**A303 Amesbury to Berwick Down  
(Stonehenge) Wiltshire  
TR010025**

**Wiltshire Council Written  
Representation**

**M1 Ratfyn Lane, London Road,**

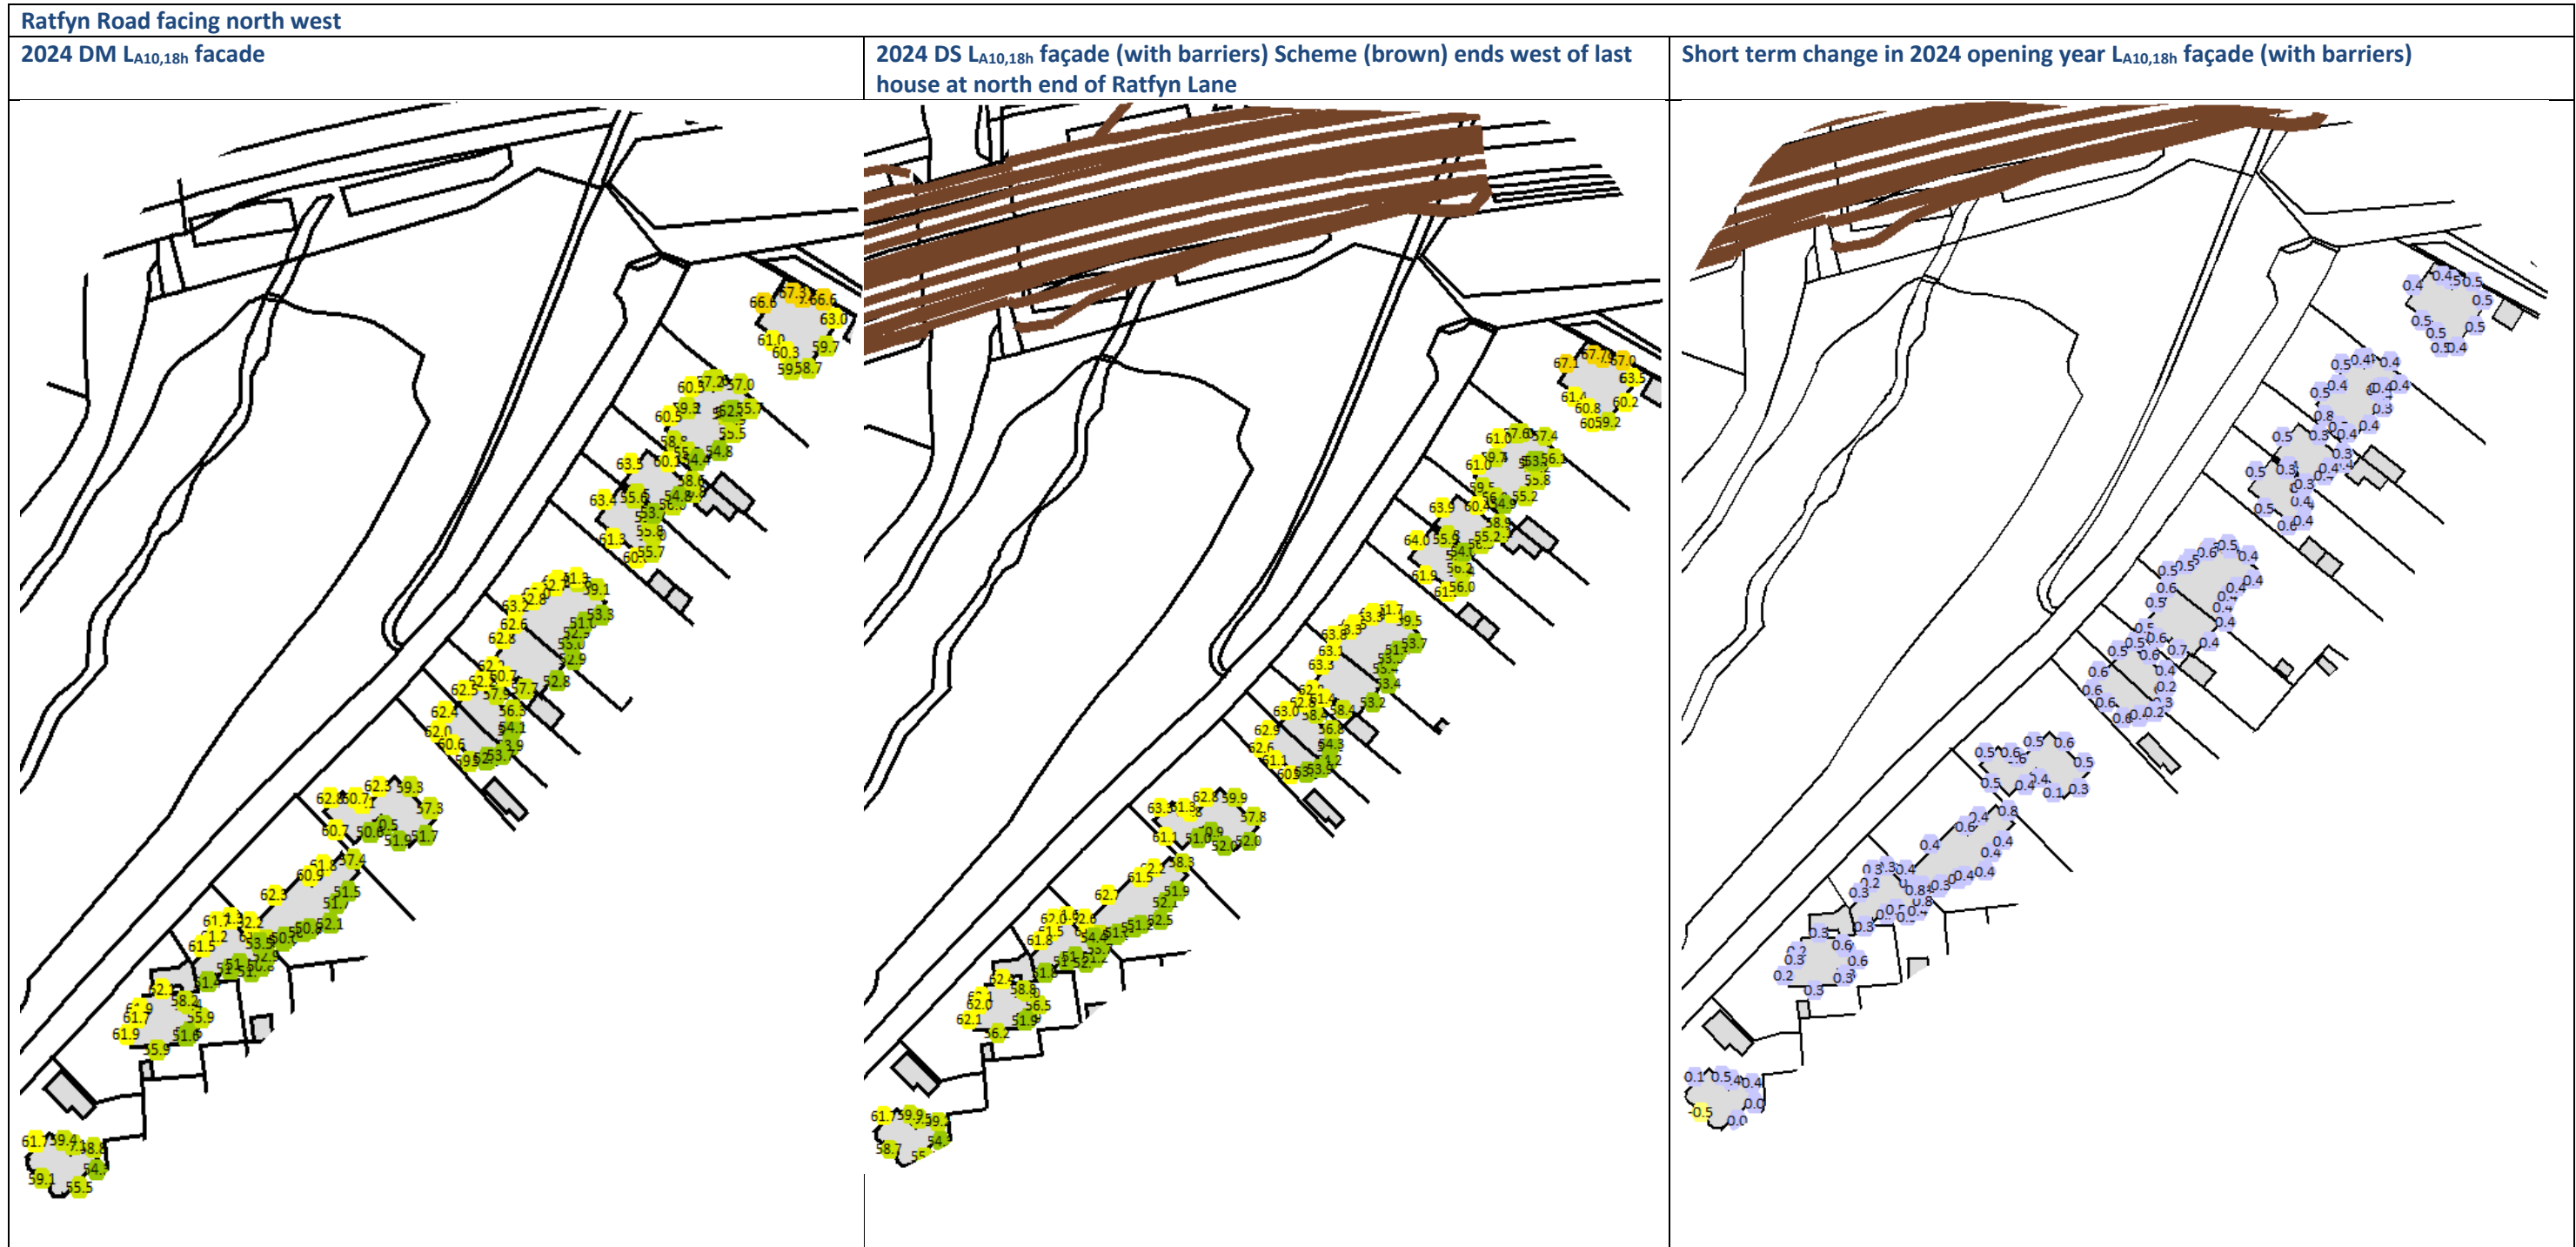
**Conclusion for Church Street/High Street**– worst affected façades moderate/major increases in traffic noise levels therefore identified as a significant adverse effect.

Comments noted and agreed. The absolute levels noted are not above triggers levels for NIR, although they are likely to be above WHO recommendations (noted the quoted figures are  $L_{A10}$ , the  $L_{Aeq}$  comparable figures will be lower). The existing levels in the area are high. the additional traffic is due to low traffic volumes and the noise level increase is therefore to be expected. Standard glazing already in place would likely reduce predicted levels sufficiently.

**London Road and Lords Croft facing north-west**

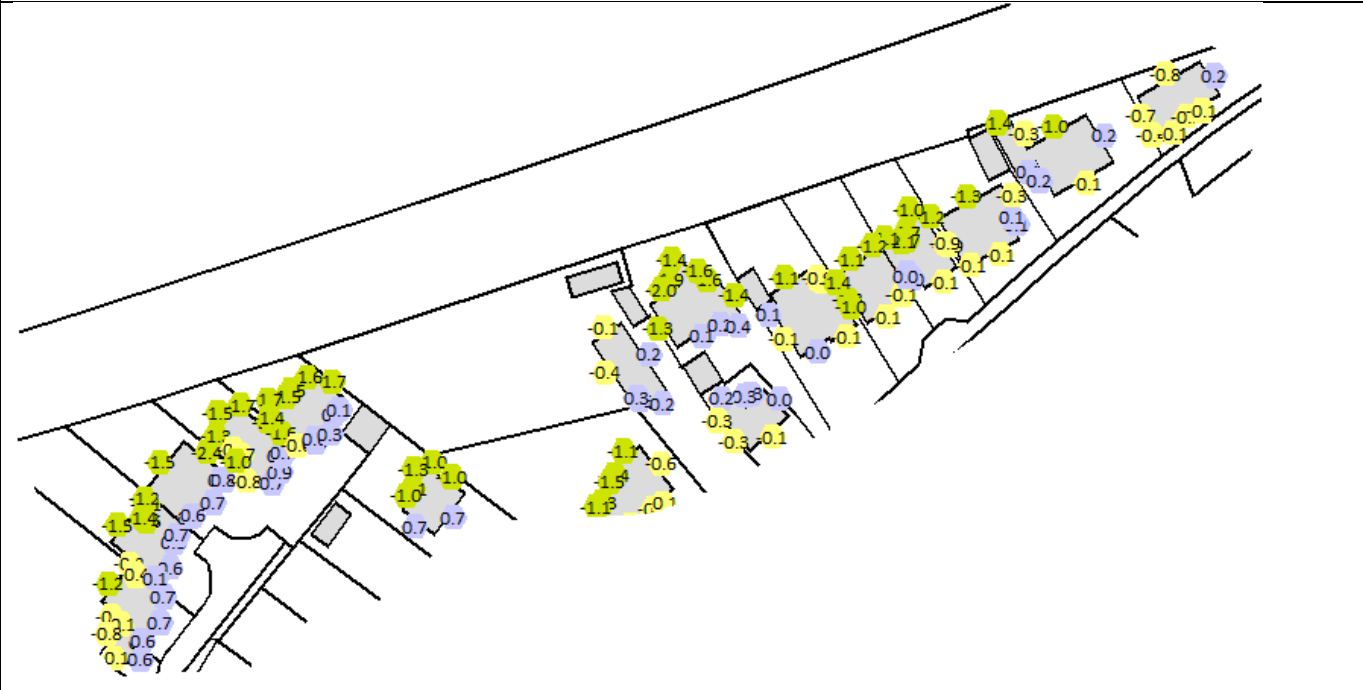
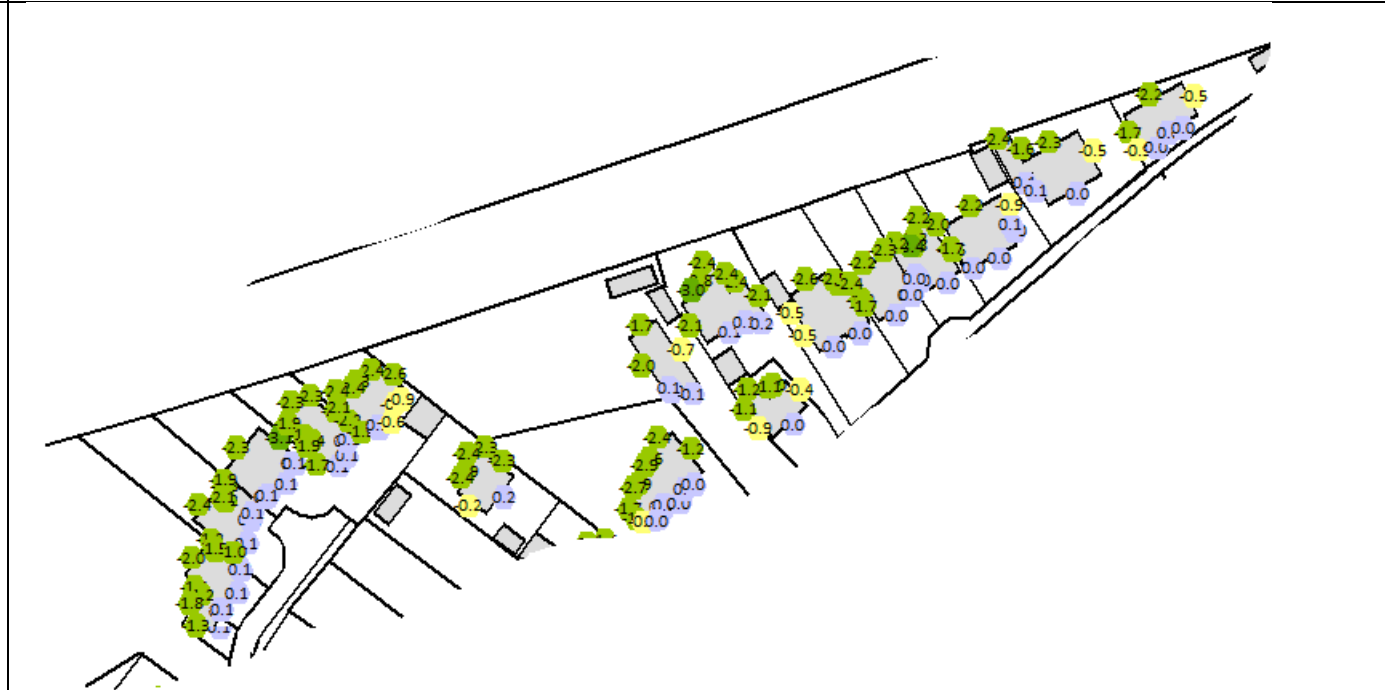
**Ratfyn Road** - Negligible increases in traffic noise levels predicted on facades facing north-west towards the A303, due to slight increase in traffic on the A303 with the scheme in operation (one of the aims of the scheme is to reduce rat running on surrounding minor roads by resolving the congestion problems at Countess/past Stonehenge). Highest noise levels at north end closest to the A303 as would be expected. Note topography means these houses are considerably elevated above the A303 up a vegetated bank. Most northern house on Ratfyn Road identified at this stage as potentially qualifying for Noise Insulation (just meets criteria). Note house next door (to south) is a bungalow hence slightly lower noise levels as reported for ground floor not first floor. Benefit of flyover noise barriers minimal at northern end (0.1dB) at southern end just over 1dB. Investigations into a noise barrier on the mainline in this determined had virtually no effect due to topography, plus limited by the scheme extents.

Agreed.

**A345 north of Countess (see extracts from noise model below)**

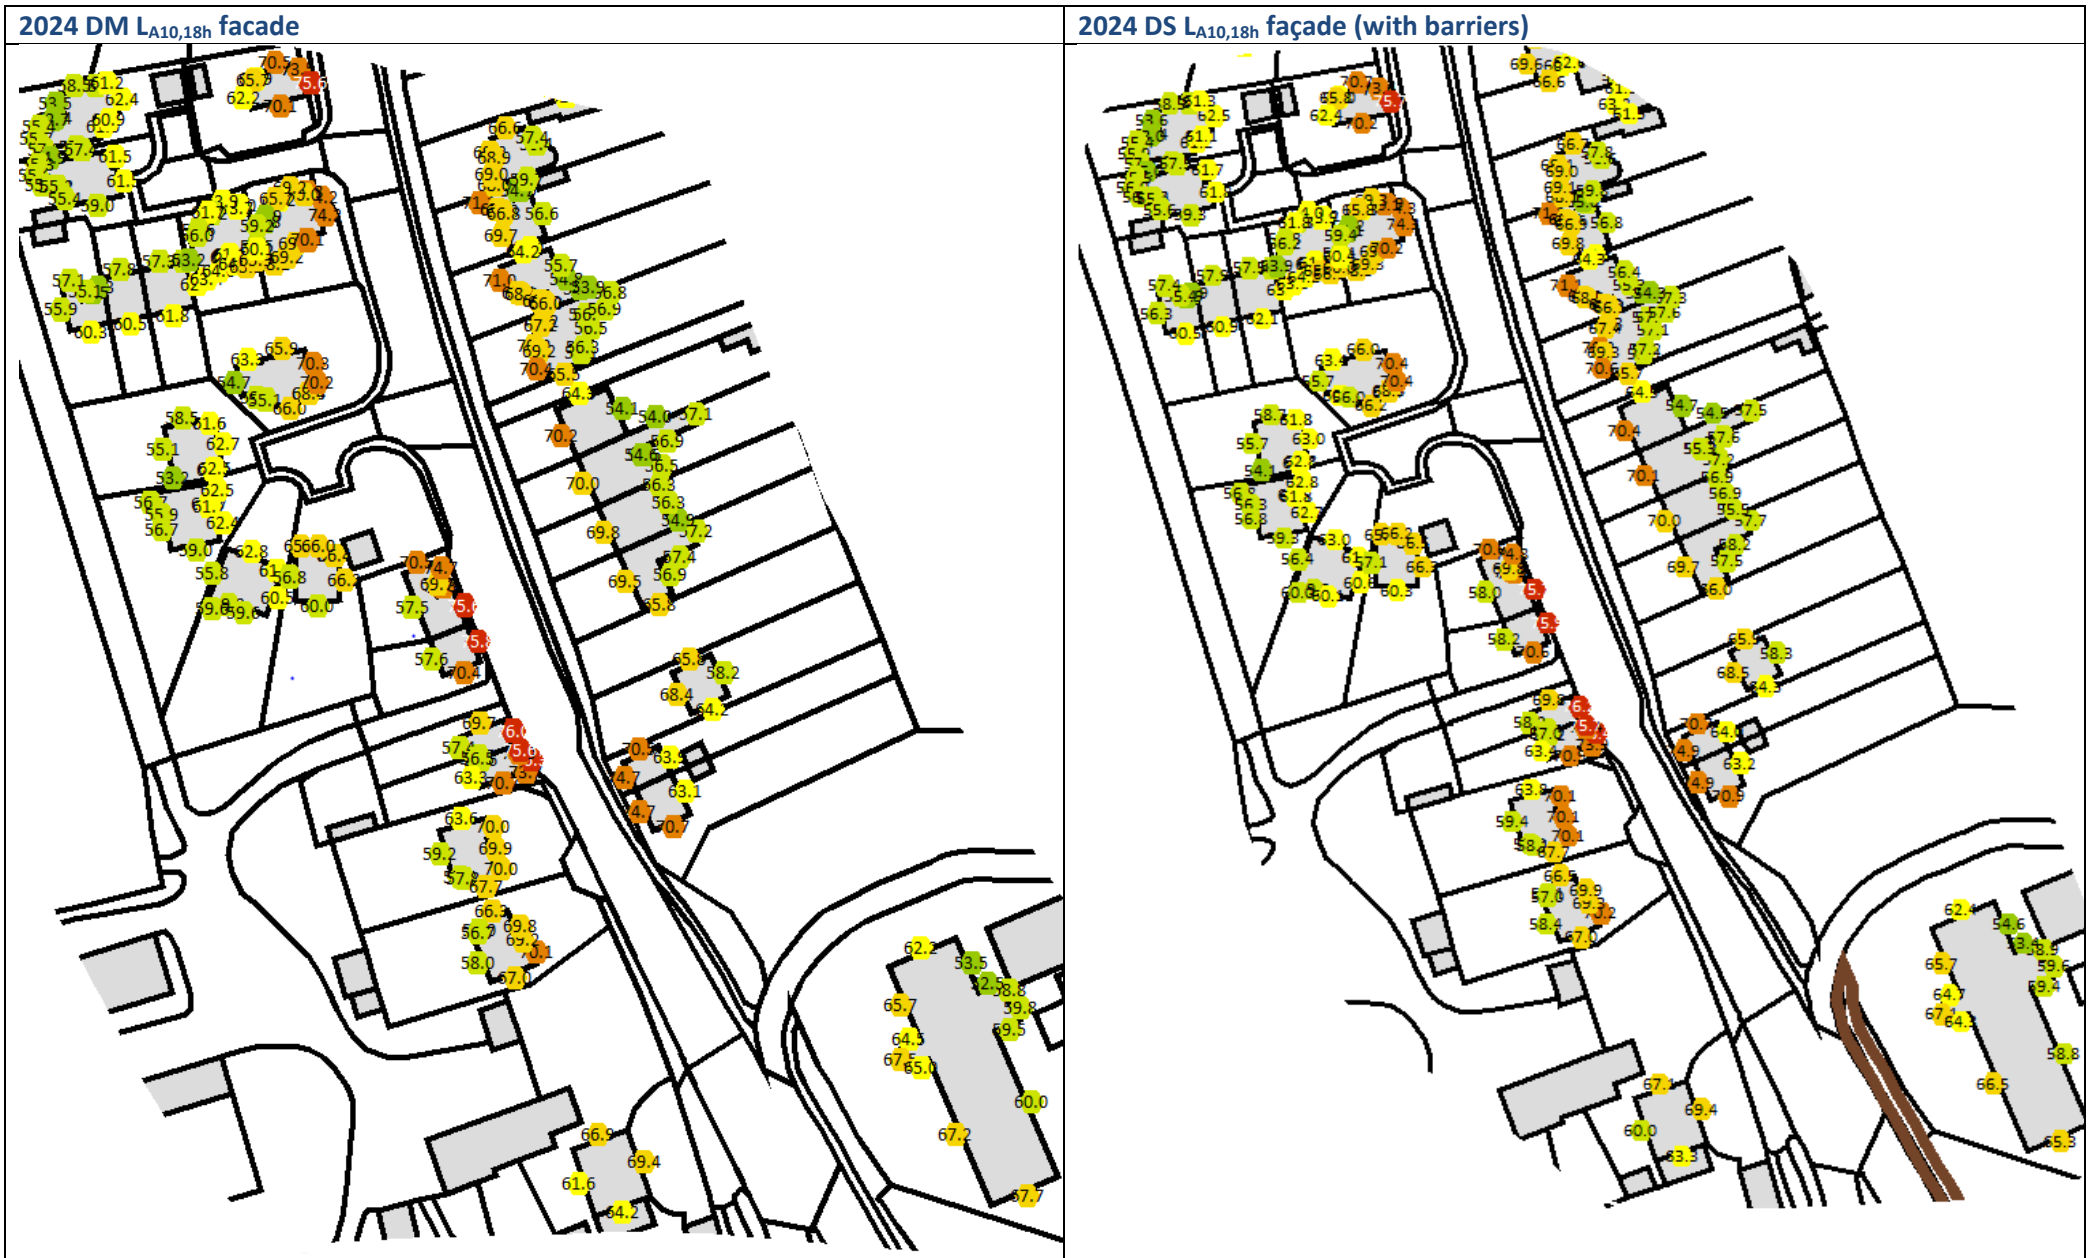
**A345 north of Countess** – Mainly negligible increases in traffic noise levels, with some minor increases at the worst affected façades, and slight benefits at very closest façades to the mainline (Countess Farm and Travelodge) where existing mainline is reused as sliproads so new mainline through centre of the junction slightly further away. Slight increase in traffic on A345 with scheme in place as congestion problems at Countess resolved. Barriers on flyover reduce impact by up to around 2.5dB. Without barriers majority of receptors would experience a minor increase.

**Conclusion for A345 north of Countess** – worst affected façades negligible/minor increases in traffic noise levels therefore not identified as a significant adverse effect. Agreed. High levels of road traffic existing currently. The proposed scheme is noted to have little or no adverse impact in terms of increase in level.
